Re: Parkhill Subdivision Unit 1, SIA/Financial Guarantee Release
Engineer's Stamp dated 2-25-02 (A11/D6)
Certification dated 2-19-04

CITY OF ALBUQUERQUE
PUBLIC WORKS DEPARTMENT
ENGINEERING DEVELOPMENT GROUP
ENGINEER'S CERTIFICATION
PARK HILL SUBDIVISION UNIT 1
GRADING & DRAINAGE PLAN

DRAINAGE CERTIFICATION

TITLE: **ENGINEER'S CERTIFICATION
PARK HILL SUBDIVISION UNIT 1
GRADING & DRAINAGE PLAN**

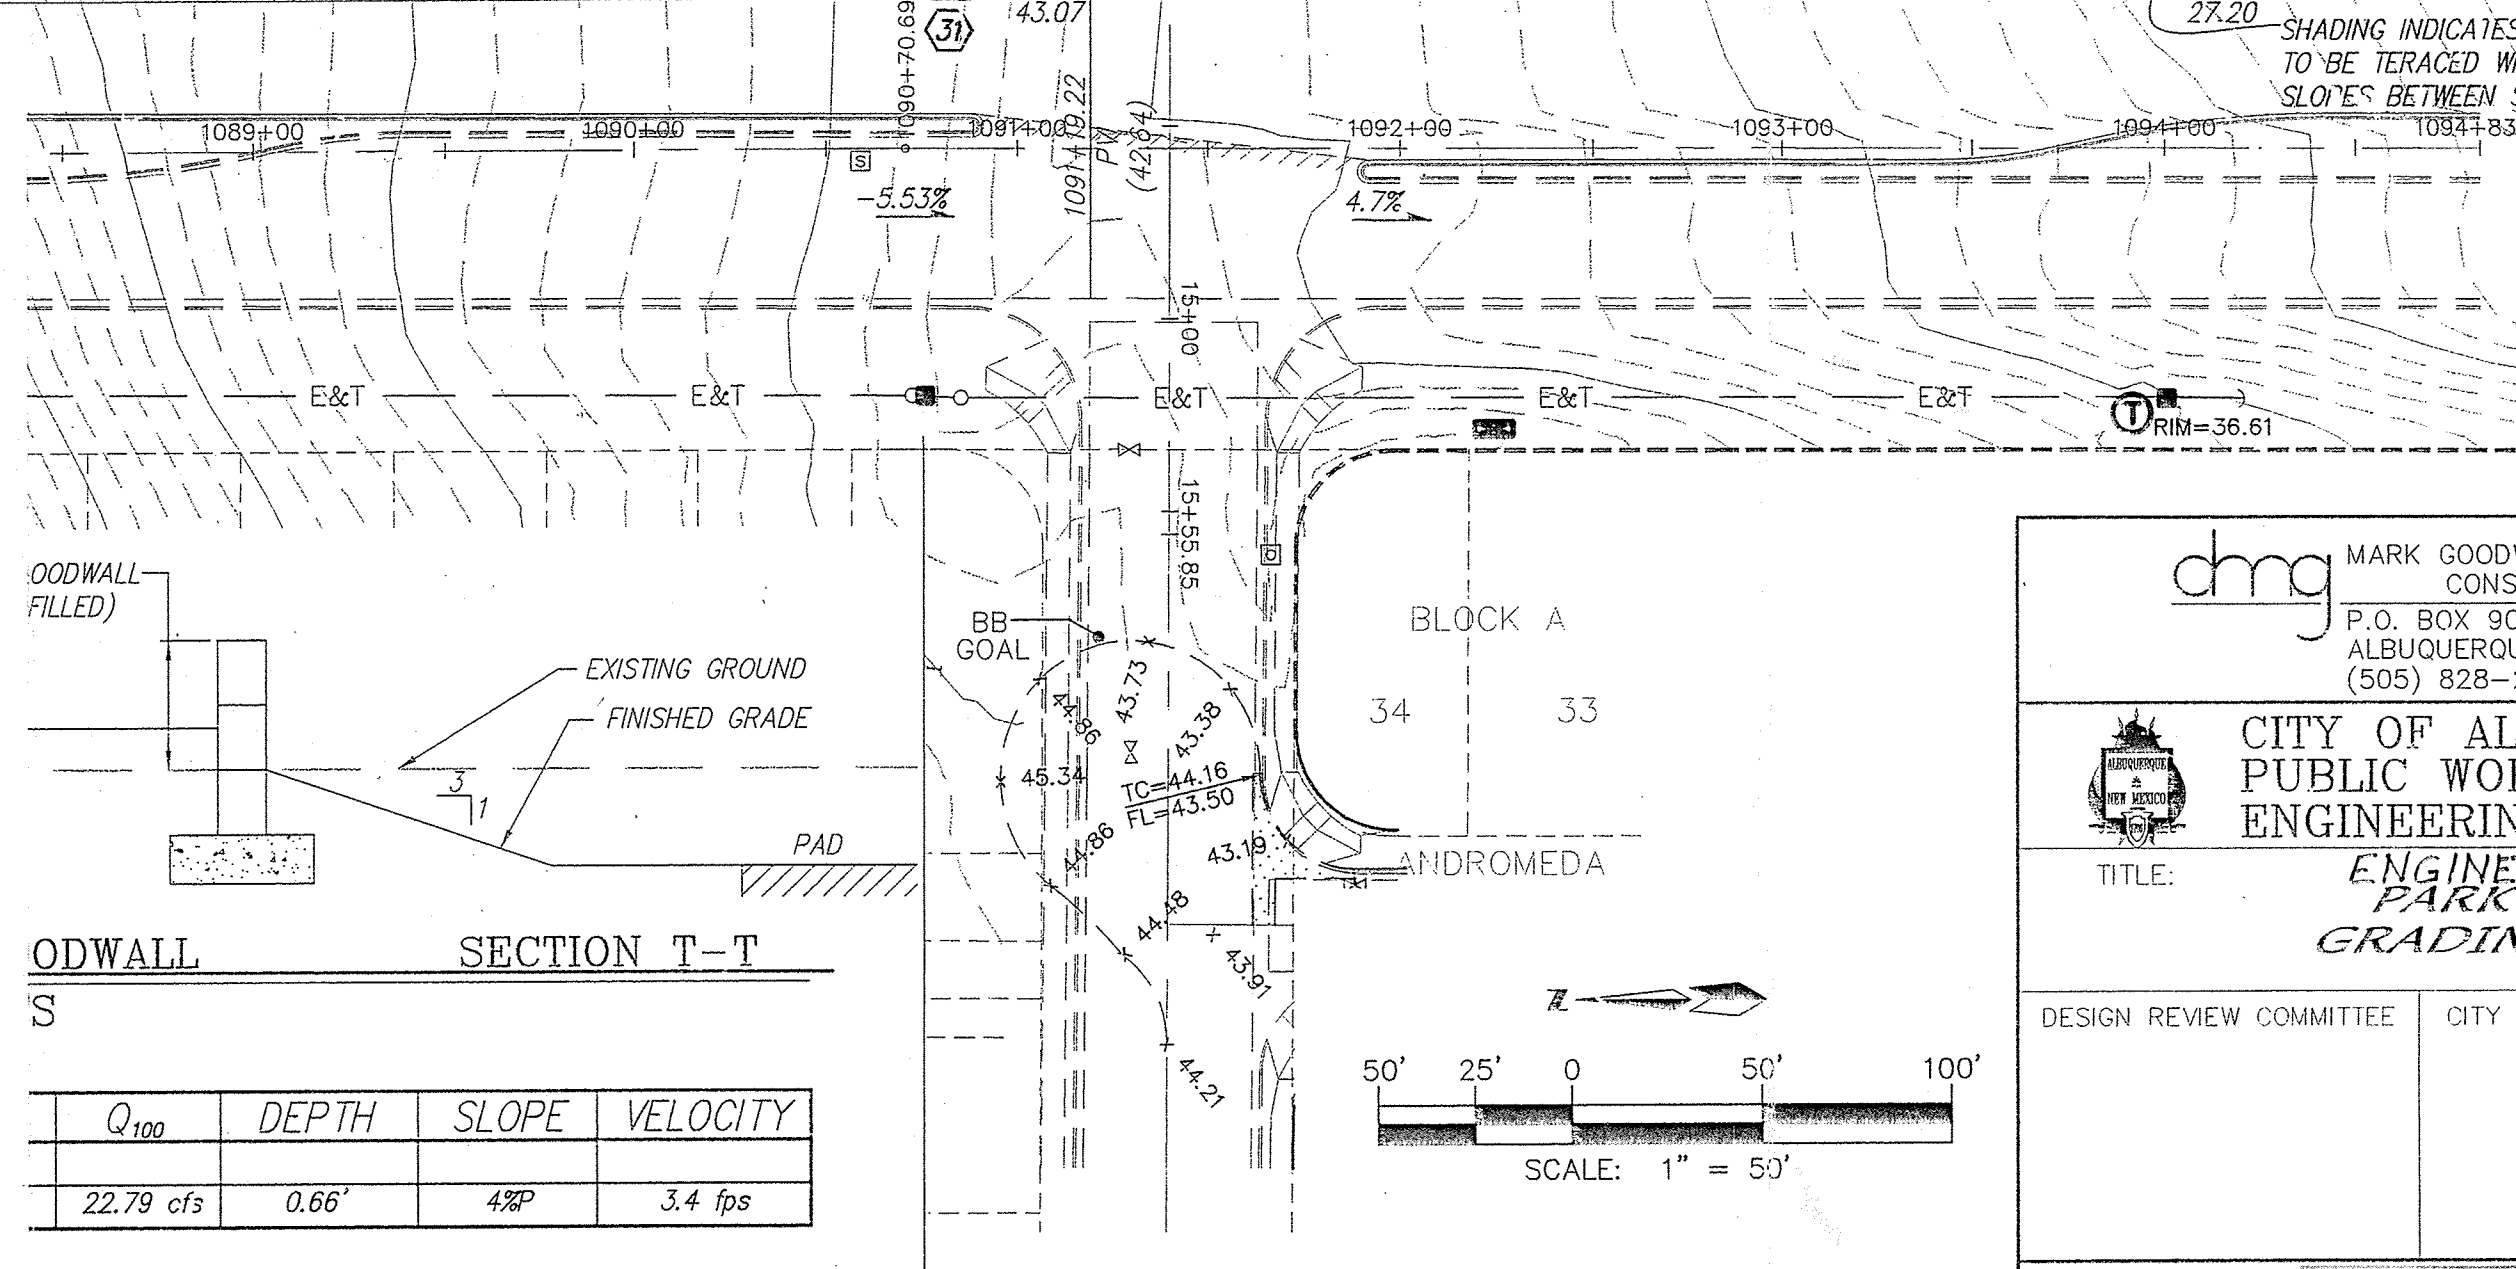
1. The side yard swales were supposed to be separated by a 6" high dirt berm that is missing on most lots. So the drainage goes into a common swale on the low side of the lot line. It does not cause a problem now, but there is no private drainage easement for this "Common" and/or "Cross Lot" drainage.

3. The floodwall on the west boundary is not part of this certification. The city building department is responsible for permitting and inspection. Silt fence prevented drainage from entering the Park North Sub street and may inadvertently divert drainage to McMahon Boulevard.

4. The grade at the rear of Lot 8, block 8 and Lot 16, block 3 is more than 18" lower than planned.
5. As-built rear property corner elevations on Lots 5-14, Block 1 are lower than planned, by as much as 1.4' but the grades have obviously been raised and will have no problem draining to the street. Similarly the asphalt northeast rear elevation of lot 16 blk 4 is 1.7 foot low, but is being raised by builder with the construction of a block garden wall to retain 1.5' on the Unit 2 side.

6. The pond at Milky Way has been filled in and replaced by the Black Arroyo Boulevard Master Storm Sewer (City Project # 6777.81). The pond is not needed.

7. Retaining wall was added to replace the slope on the rear of lots 16, 17, & 18 Block 1.

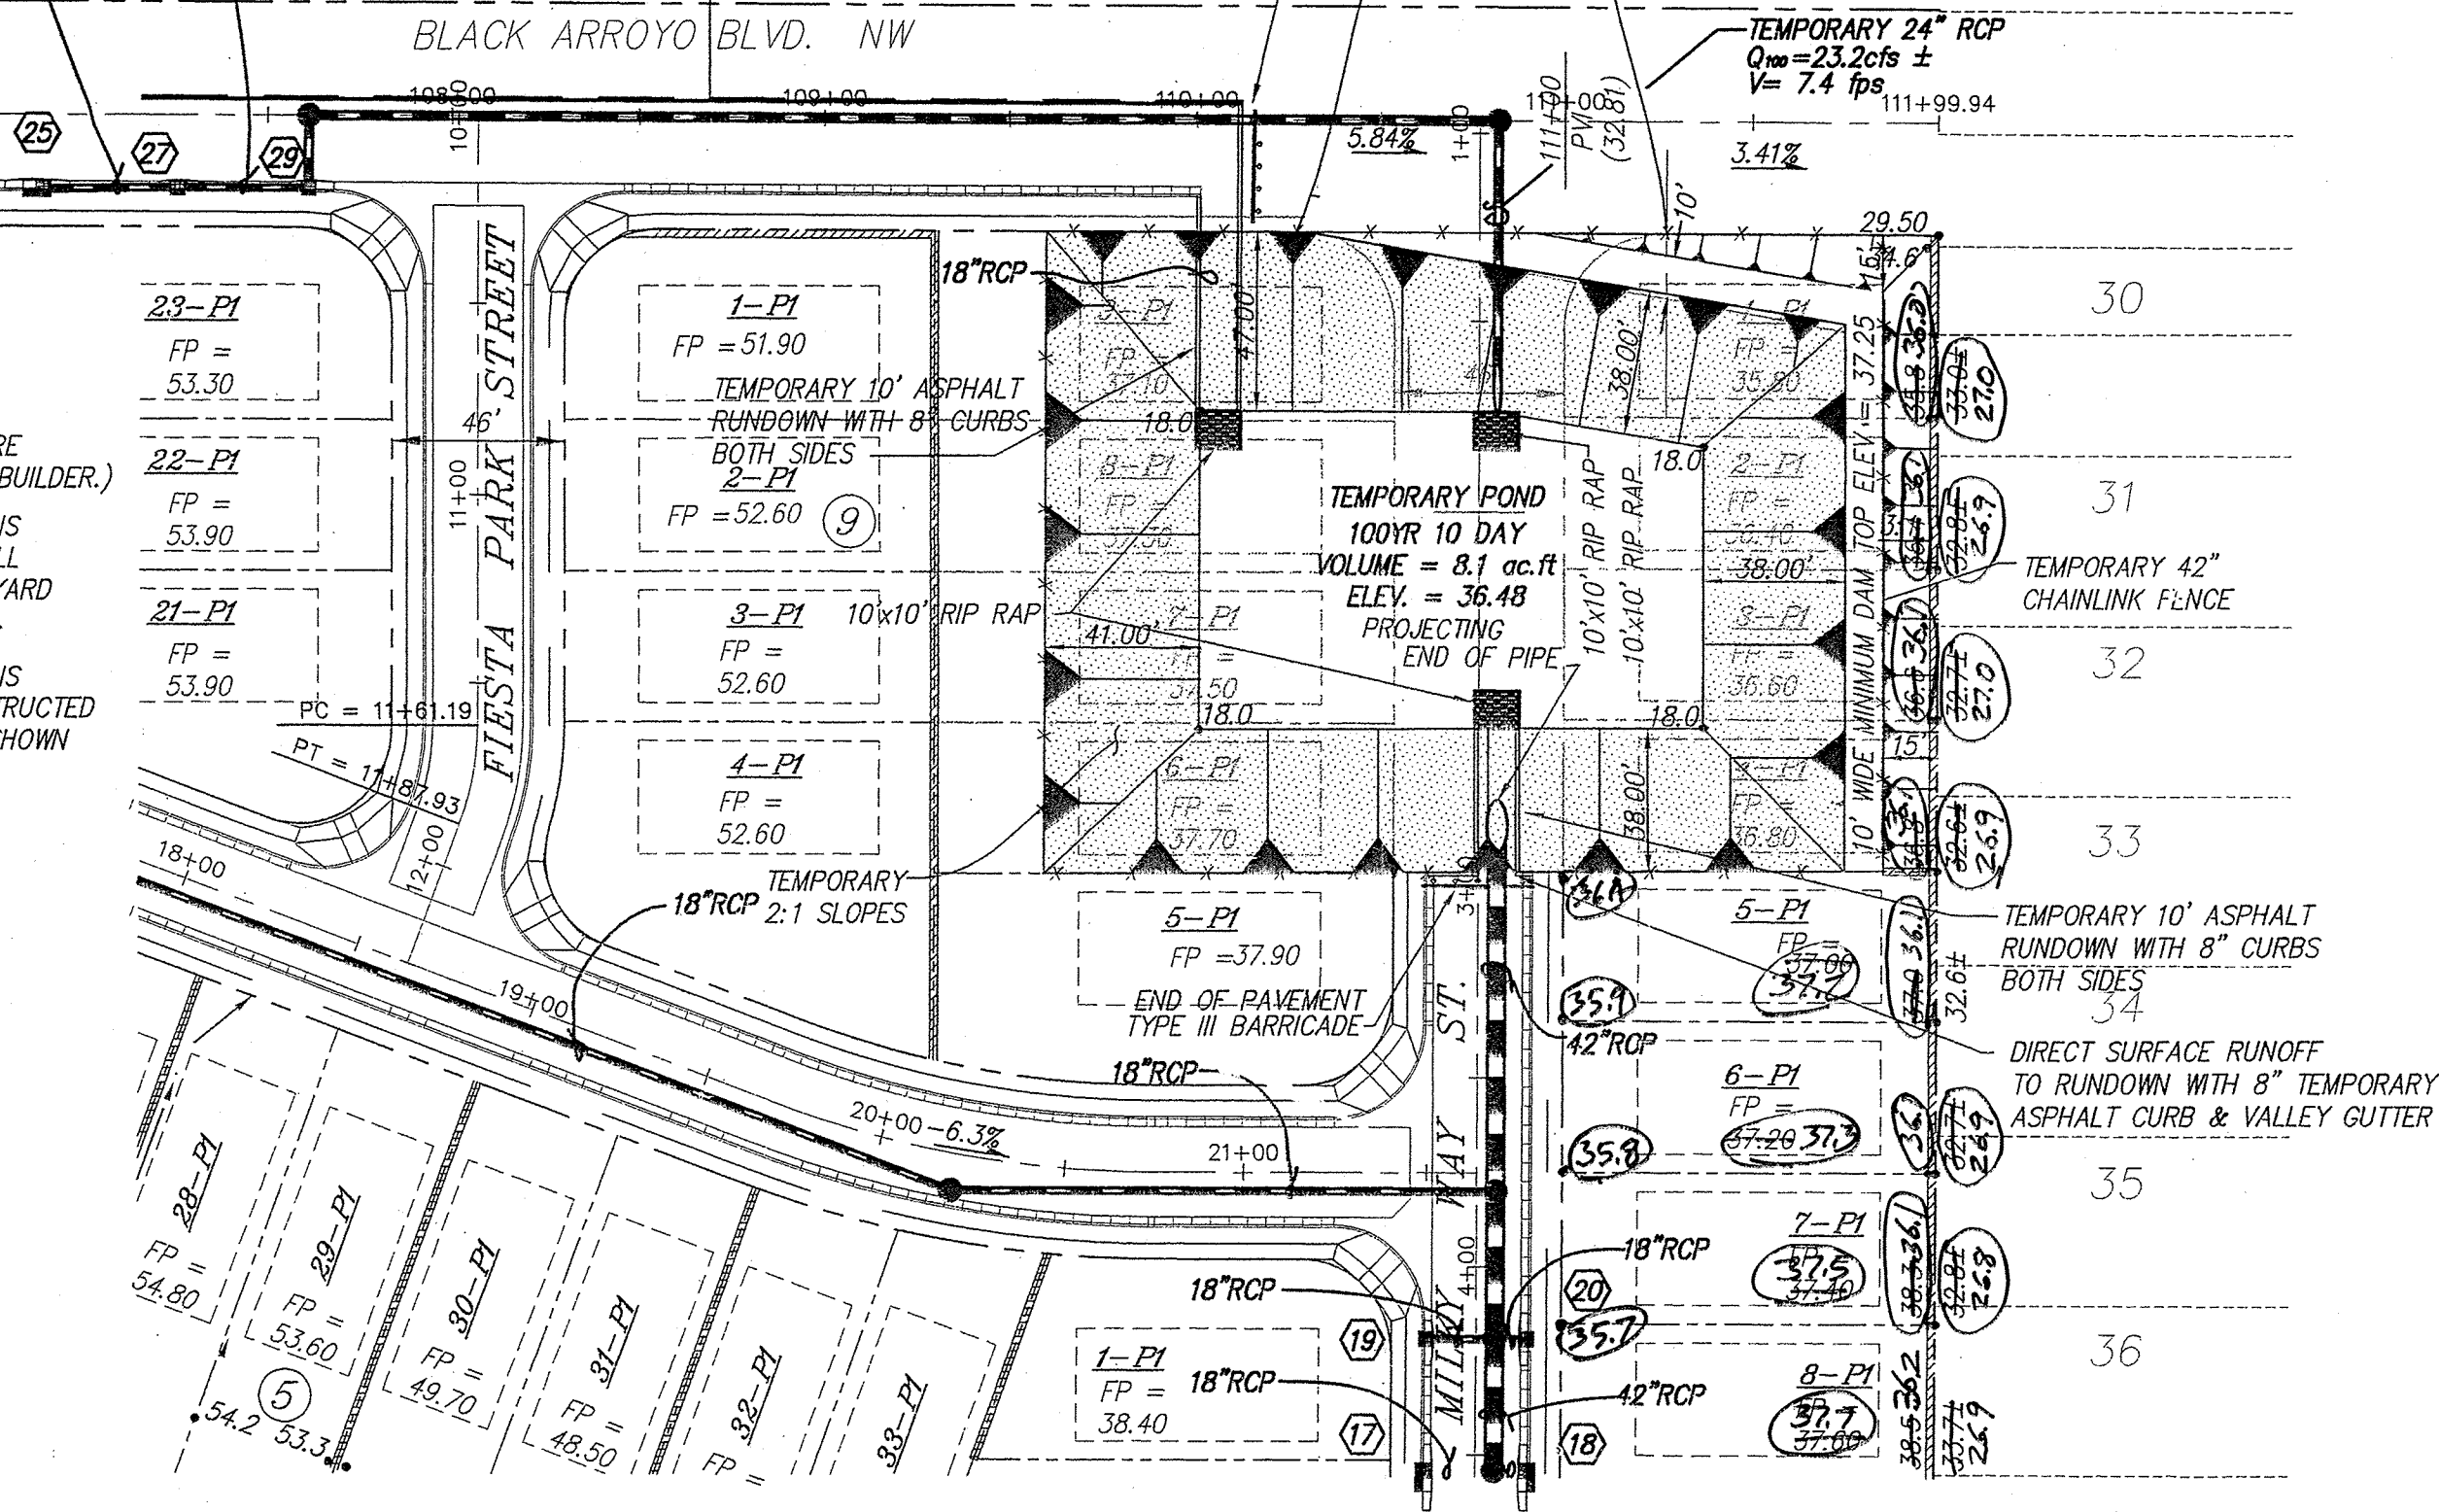
1. The side yard swales were supposed to be separated by a 6" high dirt berm that is missing on most lots. So the drainage goes into a common swale on the low side of the lot line. It does not cause a problem now, but there is no private drainage easement for this "Common" and / or "Cross Lot" drainage.

3. The floodwall on the west boundary is not part of this certification. The city building department is responsible for permitting and inspection. Silt fence prevented drainage from entering the Park North Sub street and may inadvertently divert drainage to McMahon Boulevard.

4. The grade at the rear of Lot 8, block 8 and Lot 16, block 3 is more than 18" lower than planned.
5. As-built rear property corner elevations on Lots 5-14, Block 1 are lower than planned, by as much as 1.4' but the grades have obviously been raised and will have no problem draining to the street. Similarly the asbuilt northeast rear elevation of lot 16 blk 4 is 1.7 foot low, but is being raised by builder with the construction of a block garden wall to retain 1.5' on the Unit 2 side.

6. The pond at Milky Way has been filled in and replaced by the Black Arroyo Boulevard Master Storm Sewer (City Project # 6777.81). The pond is not needed.

7. Retaining wall was added to replace the slope on the rear of lots 16, 17, & 18 Block 1.
